SUBMISSION

DR SIMON JOHN MAHON & MS SHANNON ELIZABETH MAHON
102 HILLTOP RD, AVALON 2107

RE: DA 2025/0448
100 HILLTOP ROAD, AVALON
WRITTEN SUBMISSION: LETTER OF OBJECTION
SUBMISSION: TULLOCH

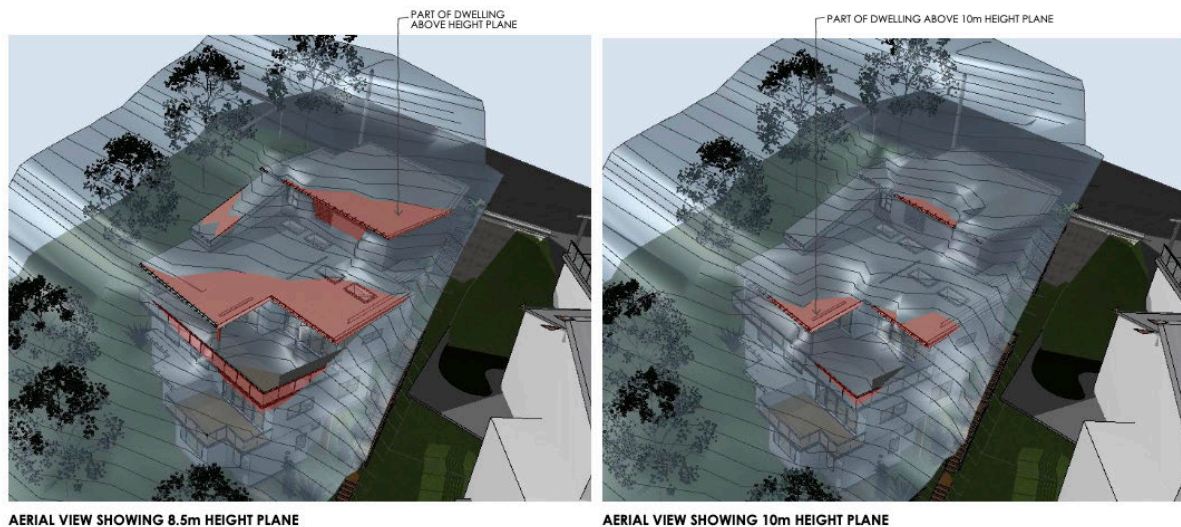
The non-compliant building envelope will lead to unacceptable visual bulk impact to neighbours. The multiple non-compliances arising from the proposed upper floor level and the non-compliant setbacks indicates that the proposed development cannot achieve the underlying objectives of this control, resulting in an unacceptable building bulk when viewed from adjoining and nearby properties.

View from Master Bedroom Level 3

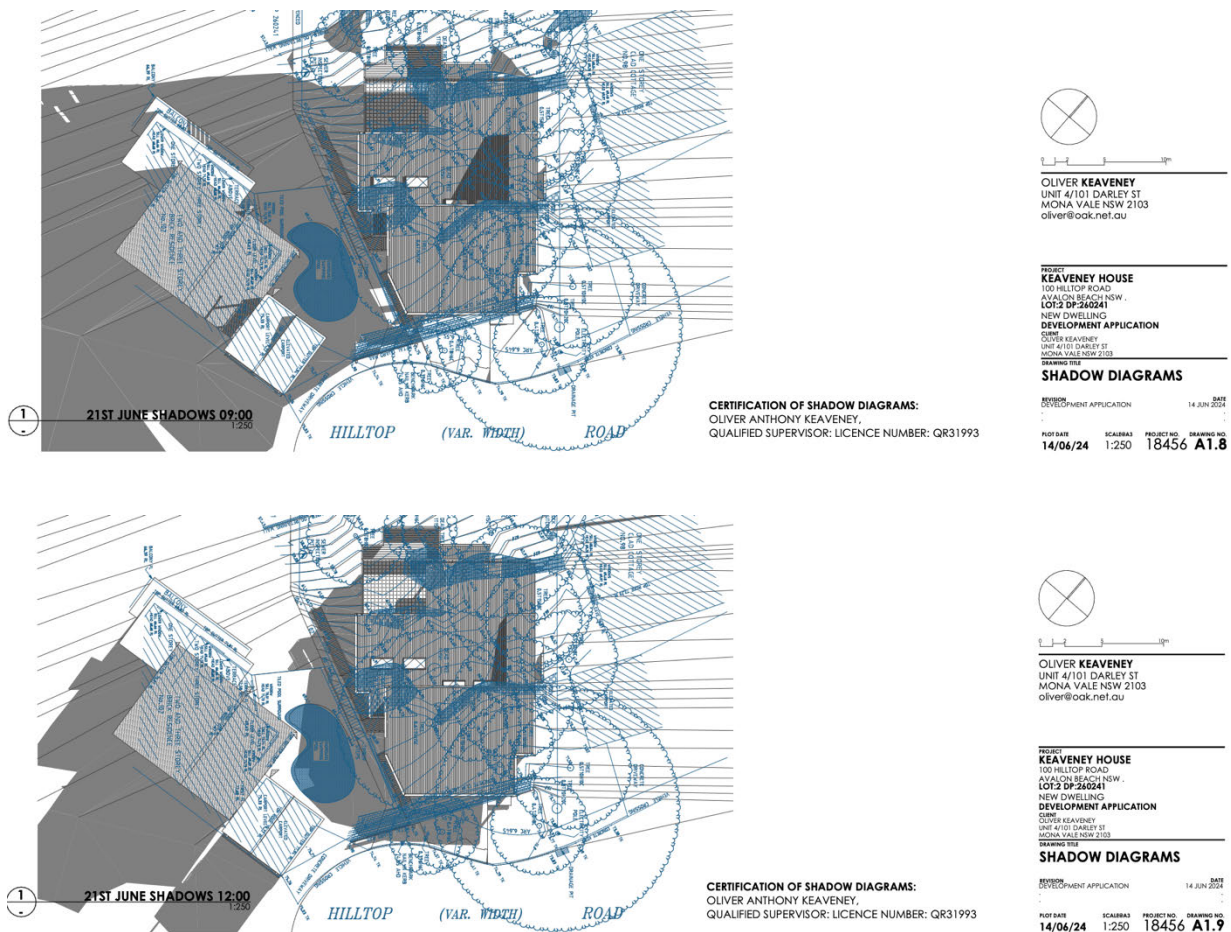
Non-compliance to Height of Building, Inclined Plane

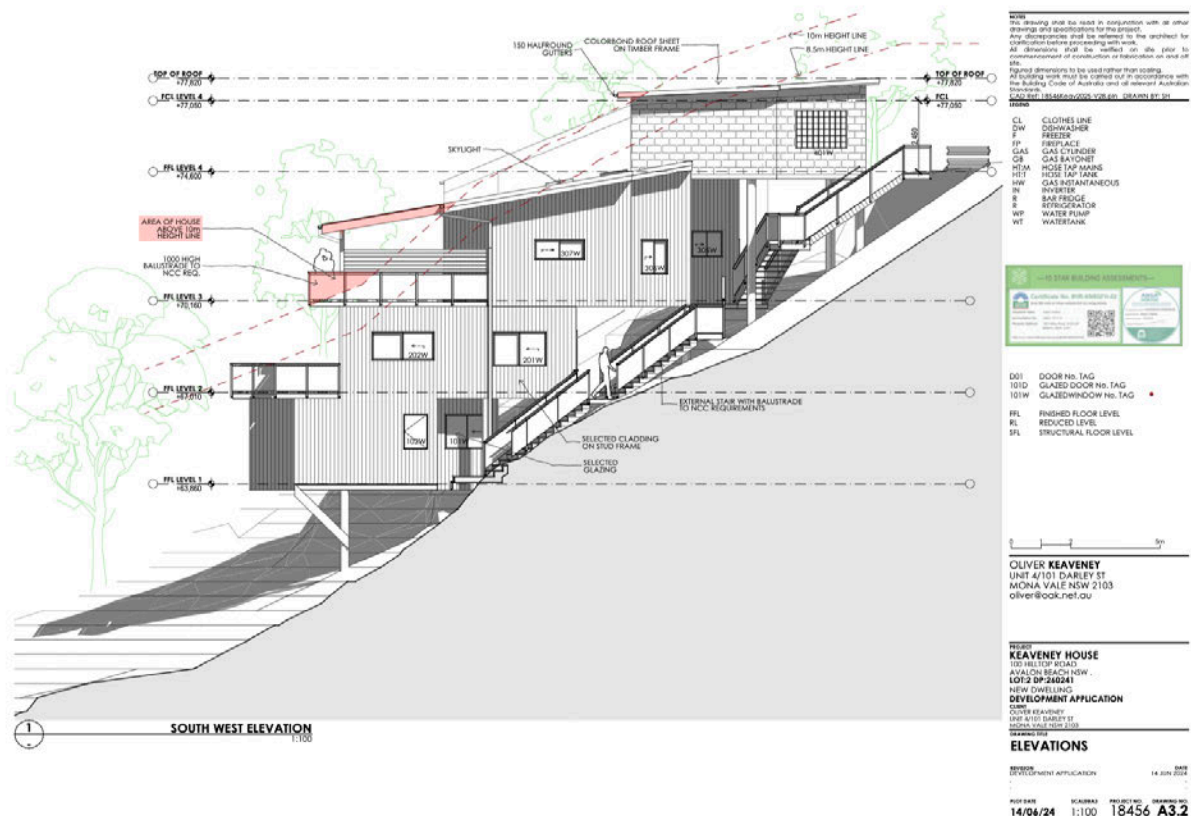
The assessment of the development against the planning principle results in the development not complying with the solar access controls and therefore amended plans should be requested to reduce the overshadowing impact on the adjoining neighbour. It is suggested that a more skilful design of the development, with a compliant envelope control, would result in less impact in regard to solar access. It is requested that Council seek amended plans for the development to reduce the impact of the development, and these matters are addressed elsewhere in this Written Submission.

I object to solar loss to the neighbour's private open space, and to the neighbour's windows that fails to allow mid-winter solar access into highly used room by non-compliant development controls.
